Development Code Amendment Matrix
May 28, 2025 – Planning Commission Meeting

Minor Amendments – Development Regulations & Zoning Map

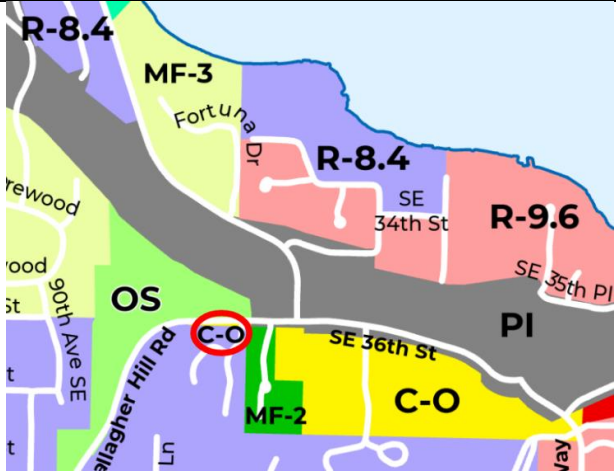
4	Nice	 <p>This appears to be an errant C-O unless there’s a small sliver of C-O zoned land here (there is a tiny sliver of yellow too).</p>	This area of C-O zone in the ROW was inadvertently left over after the adoption of the Open Space Zone, which included the rezoning of Gallagher Hill Open Space directly across the street. This error can be corrected in the PC’s Zoning Map recommendation.
